Access Compliance Report

Public Rights-of-Way

(Curb Ramps)

Intersection ID: 5855	Main Street: W_SUGAR_CREEK_RD	Cross Street: NEVIN_RD	Location:	E
ADA ID: 95D6DC9AB5E1	Ramp Type: Perp	Initial Pass/Fail: Pass	Overall Compliance: No	Severity Score: 5.25
Codes/Mitigation Info/Possible Solution		Field Measurements/Component Compliance

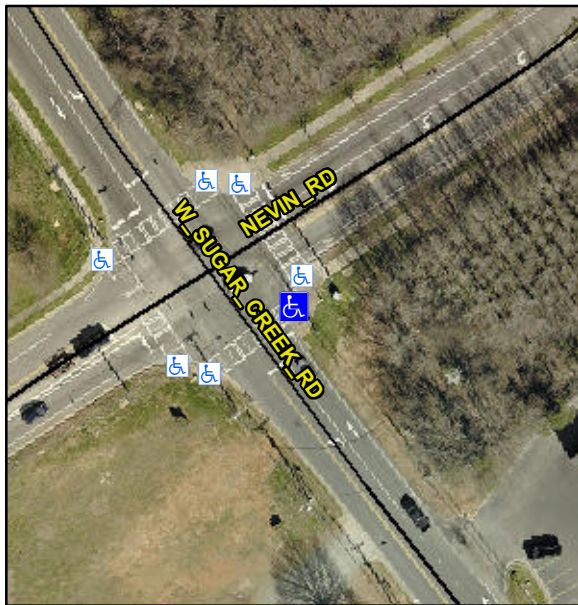
Not Found, R304.5.3, R304.5.4

Compliance	Description	Data	Compliance	Description	Data
N/A	Ramp Length (in)	72.5	Yes	Ramp Slope (%)	7.8
Yes	Ramp Width (in)	48.5	No	Ramp XSlope (%)	3.1
N/A	Flare Type LT	Sloped	N/A	Flare Type RT	N/A
N/A	Flare Slope LT (%)	1.5	N/A	Flare Slope RT (%)	10.3
N/A	Flare Traversable LT?	No	N/A	Flare Traversable RT?	No
Yes	Landing Length (in)	81.0	Yes	DWS Provided?	Yes
Yes	Landing Width (in)	48.5	Yes	DWS Contrast?	Yes
Yes	Landing Slope (%)	0.5	Yes	DWS Length (in)	24.0
No	Landing X Slope (%)	2.8	Yes	DWS Full Width?	Yes
N/A	Landing Curb? (Y/N)	No	Yes	DWS Offset (in)	1.5
N/A	Shared Landing?	No			
Yes	Gutter Ponding?	No	No	Gutter Slope (%)	6.1
Yes	Gutter Lip Ht (in)	0.0	No	Gutter X Slope (%)	2.6
N/A	Painted X Walk1?	Yes	N/A	Painted X Walk2?	N/A
	X Walk 1 Direction	To W		X Walk 2 Direction	N/A
N/A	X Walk 1 Width (in)	113.0	N/A	X Walk 2 Width (in)	N/A
	X Walk 1 Slope (%)	5.5		X Walk 2 Slope (%)	N/A
	X Walk 1 X Slope (%)	0.8		X Walk 2 X Slope (%)	N/A

**Remove & Replace Entire Ramp.
Remove & Replace Gutter.**
